# CITY OF ALBUQUERQUE

RE: Chick-fil-A on Wyoming
2274 Wyoming Blvd. NE
Requested for 30 Day Temporary C. O. - Accepted
Engineers Stamp Date 6/23/15 (H20D003C)

Based on the certification provided in your submittal received 12/10/2015, the above referenced is approved for a 30-day Temporary Release of Occupancy by Hydrology. However, before a permanent CO can be accepted the following comments must be addressed.

C-3.0

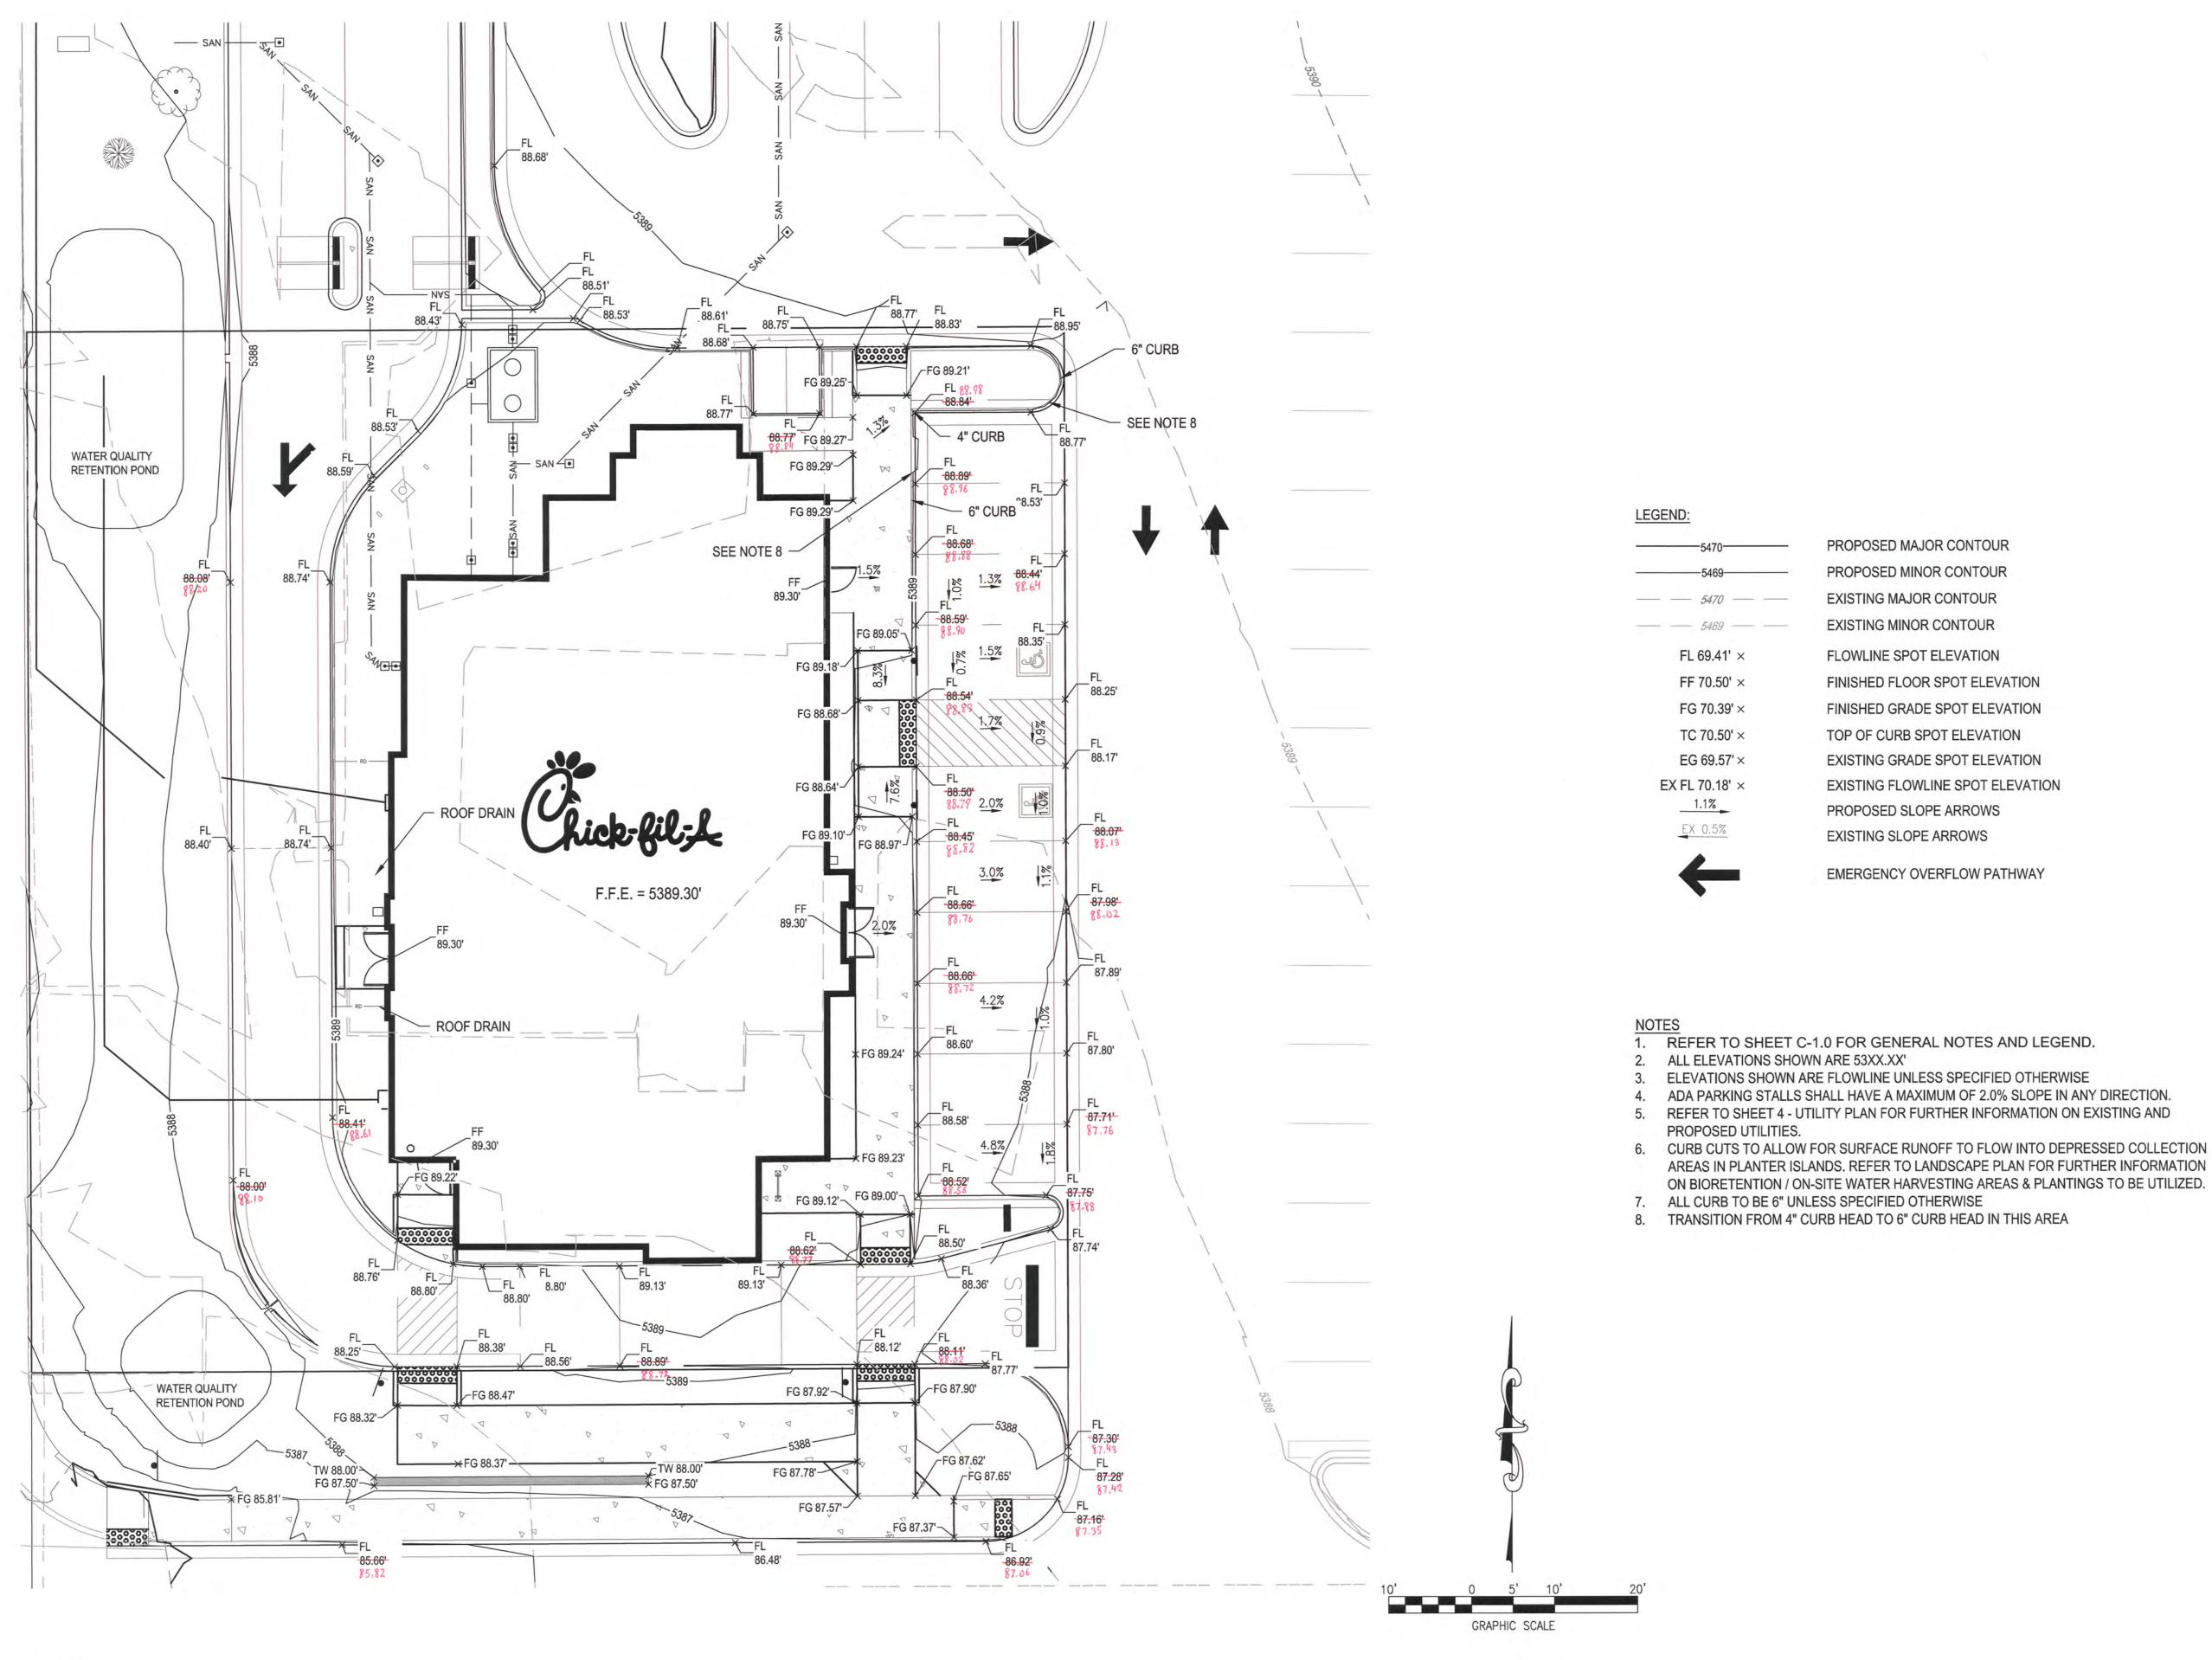
- The pond on the southwest corner must be completed.
- The pond on the west side must be completed.
